Stockmans Barn
Church Farm Walk
Upper Beeding
BN44 3HD

**OBJECTION - To Flood Risk Assessment and Outline Drainage Strategy
P25083_R3_Rev3**

Church Farm: Flood Risk Assessment and Outline Drainage Strategy P25083_R3_Rev3

Fairfax Location Plan: 2517 - PL01 Location Rev A - HDC Received: 25/08/2026

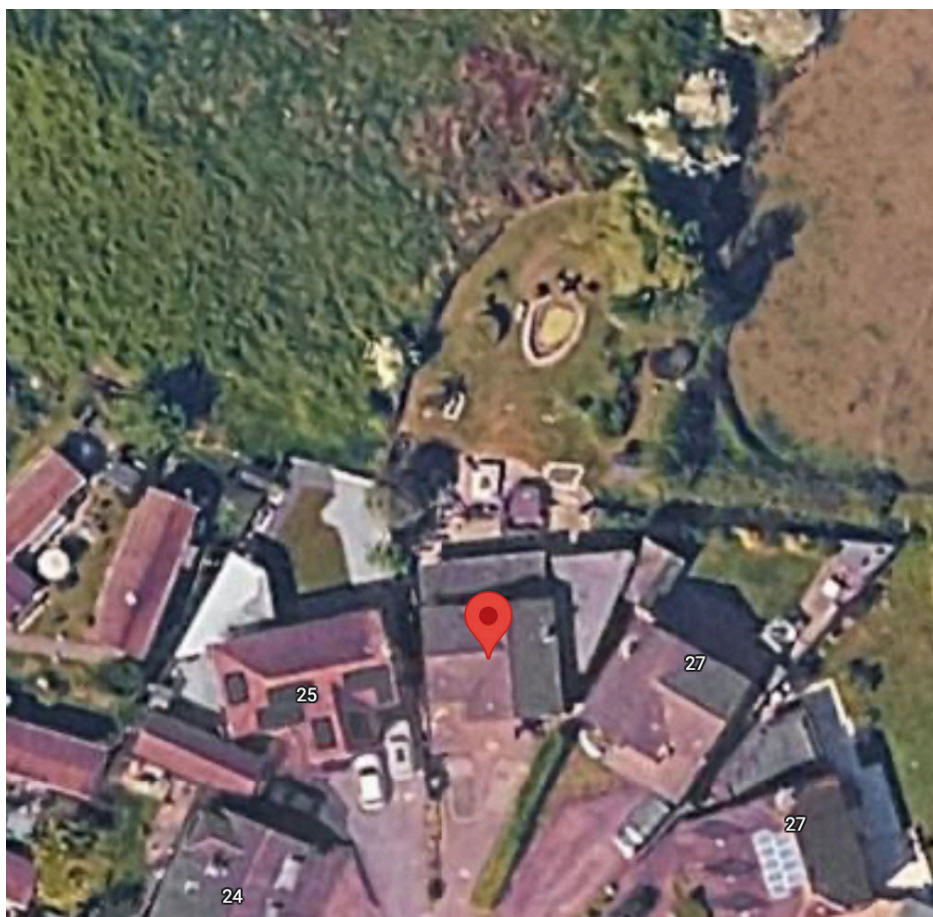
The proposed surface-water outfall from the swale is a particular concern because it is located immediately adjacent to the garden of No. 26 Driftway. The Flood Risk Assessment and Outline Drainage Strategy Rev3 does not demonstrate that this receiving location can safely accommodate the proposed discharge without increasing flood risk to the adjoining property.

The figure above shows the outfall of the drainage system in relation to the garden of property 26 The Driftway.

Appendix I - Hydrology Walkover Notes

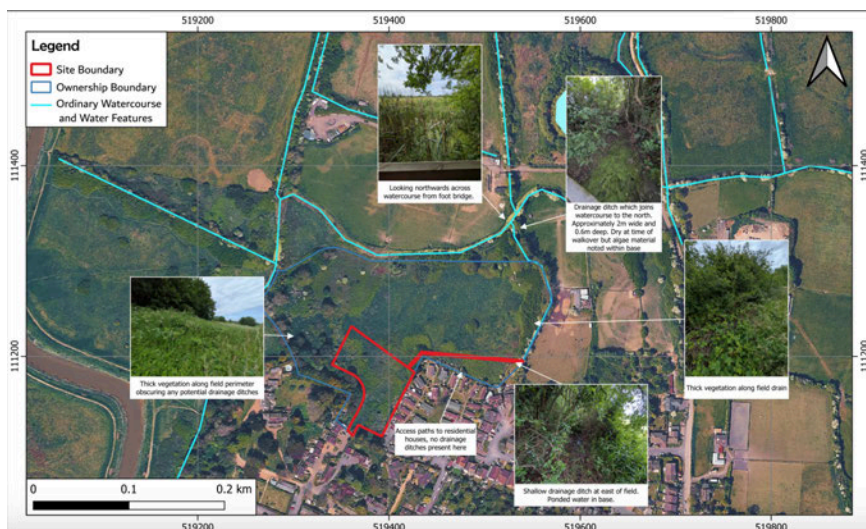
The above photo, taken from the Hydrology Walkover Notes below, shows thick vegetation potentially obstructing the drain.

Figure 2-3 Superficial deposits

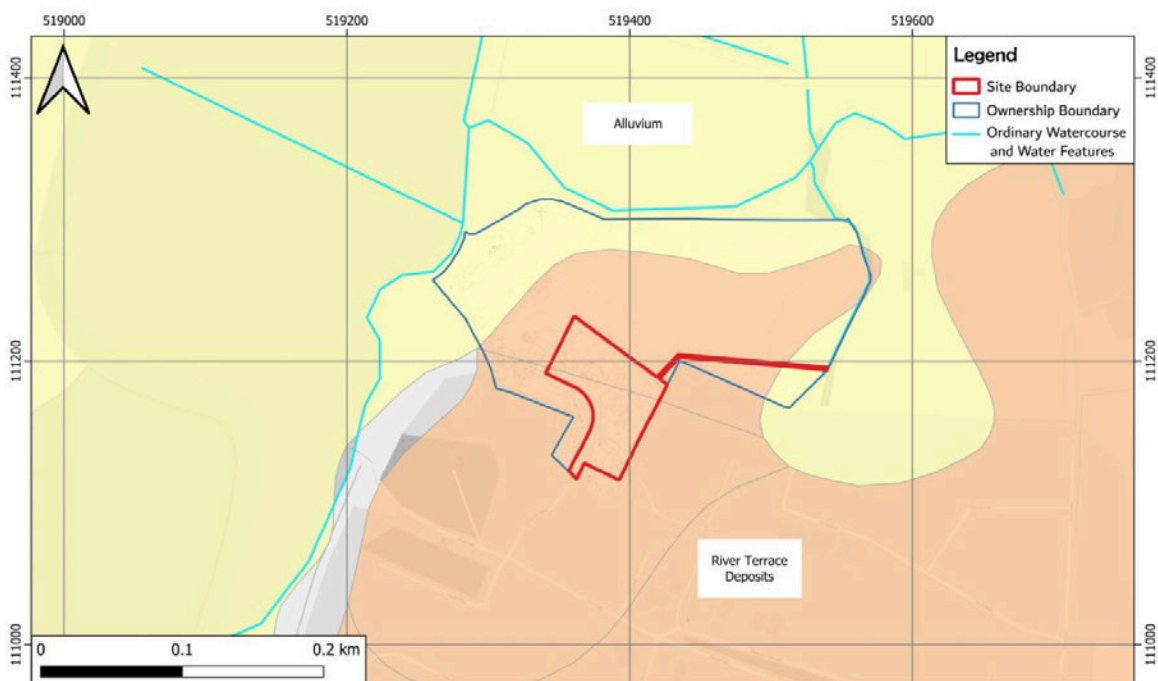
As can be seen above alluvium deposits are present in the area of the outfall, The Driftway, The Paddocks and the horse stables.

Figure 4-3 Risk of Flooding from Surface Water

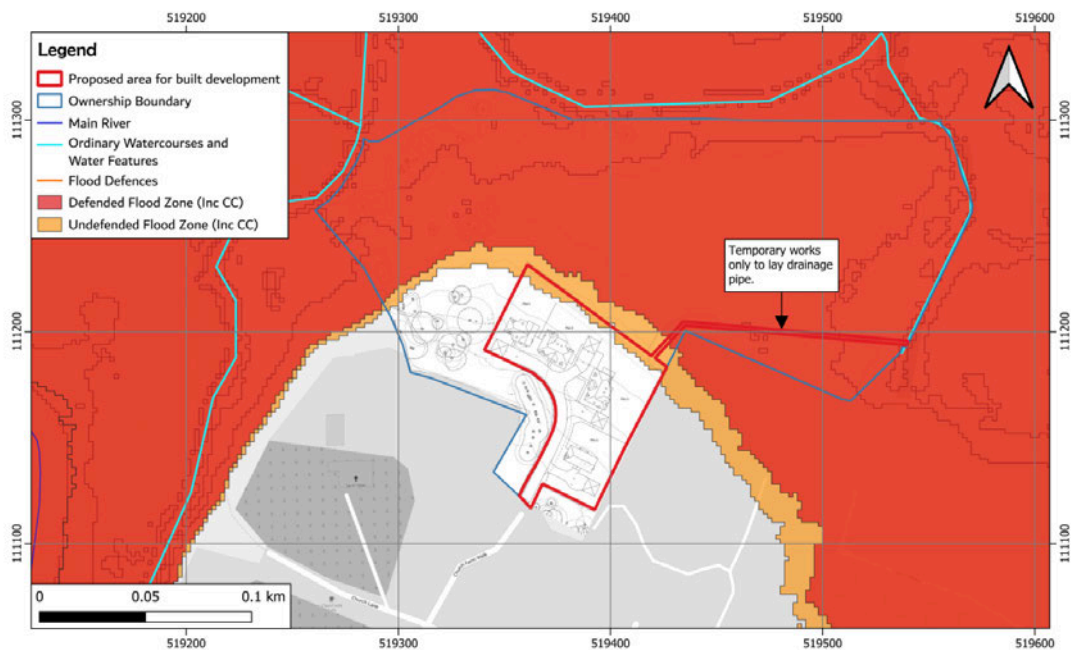
As can be seen in figure 4-3 below the area of the outfall and The Driftway, The Paddocks and the horse stables are at high risk of flooding from surface water.

The figure above shows the high risk of surface water flooding at the outfall, The Driftway, The Paddocks and the horse stables.

Figure 2-2 Existing ground elevations from LiDAR data

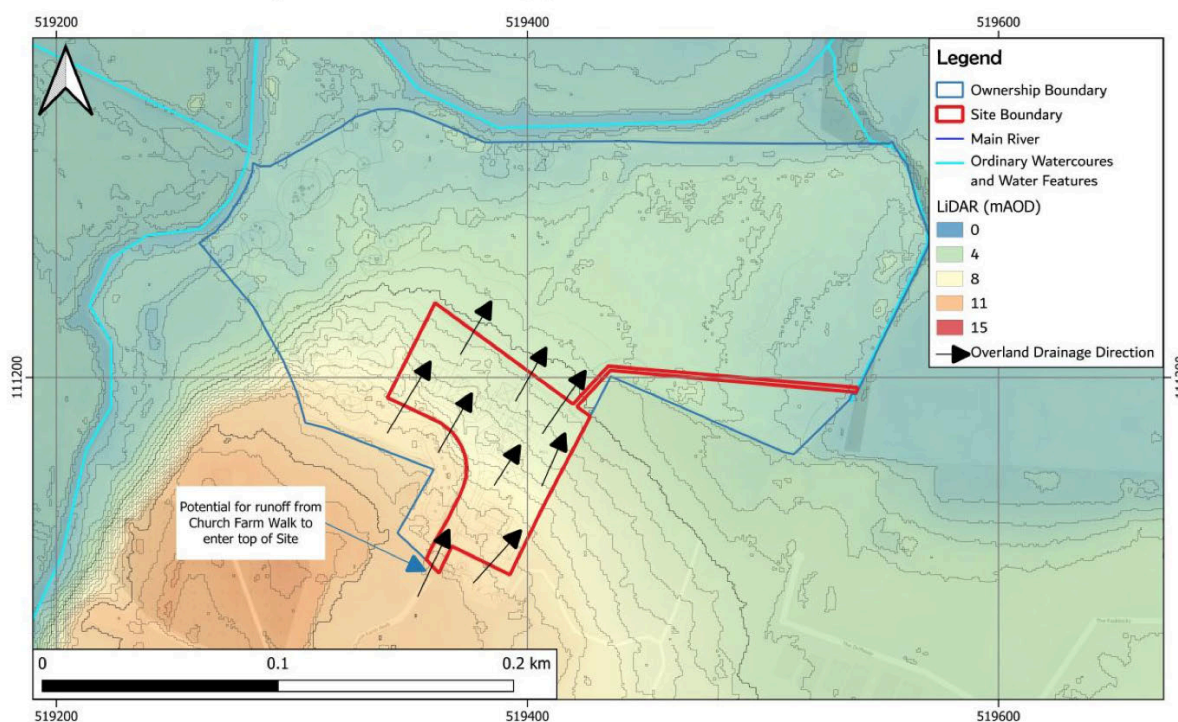
In the figure above the area of the outfall The Driftway, The Paddocks and the horse stables can be seen to have low ground elevations from 0m AOD to 4m AOD. It appears that the 0m AOD elevation extends from the outfall towards 26 The Driftway.

The figure above shows the 0m AOD extending from the outfall to 26 The Driftway.

Figure 6-2 Properties of key SuDS features

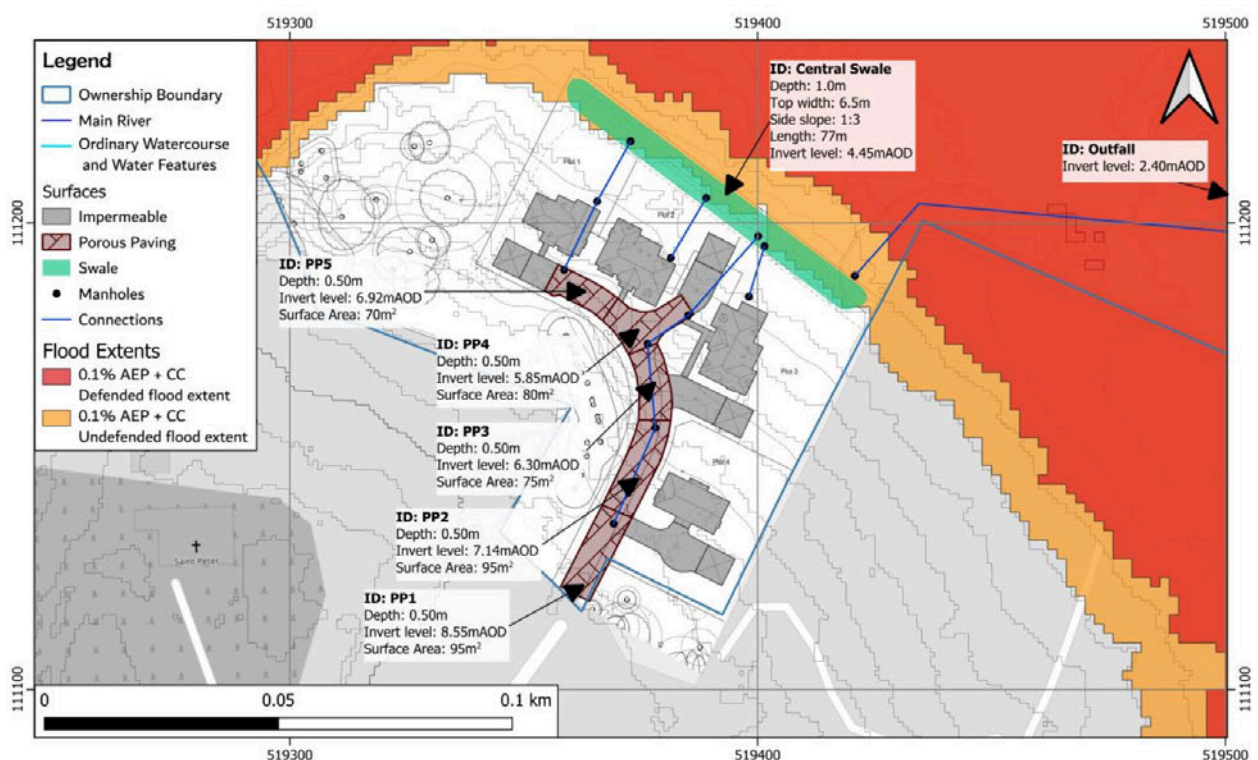
There is also an apparent discrepancy which should be resolved before the drainage proposal can be regarded as satisfactorily demonstrated. **Section 6.2.3 and Figure 6-2** identify the outfall/drain invert as approximately **2.4m AOD**, whereas the **Causeway model** identifies the outfall node with an invert of **1.0m AOD**. The model should be reconciled with the proposed physical drainage design because the levels are directly relevant to the hydraulic performance of the outfall.

The above figure shows the 2.40m AOD discrepancy.

Appendix D Proposed Drainage Plan

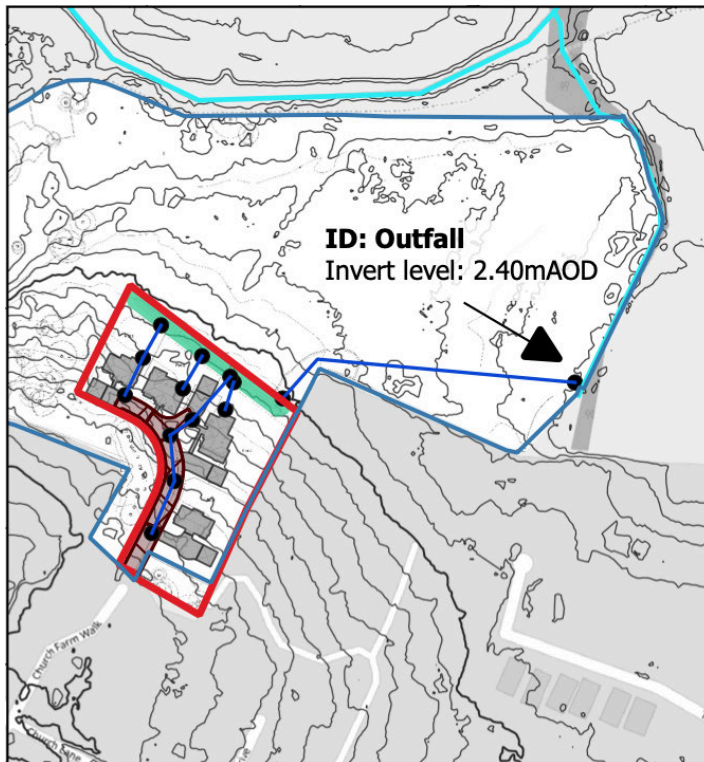
The above figure taken from appendix D provides further evidence of the 2.40m AOD discrepancy.
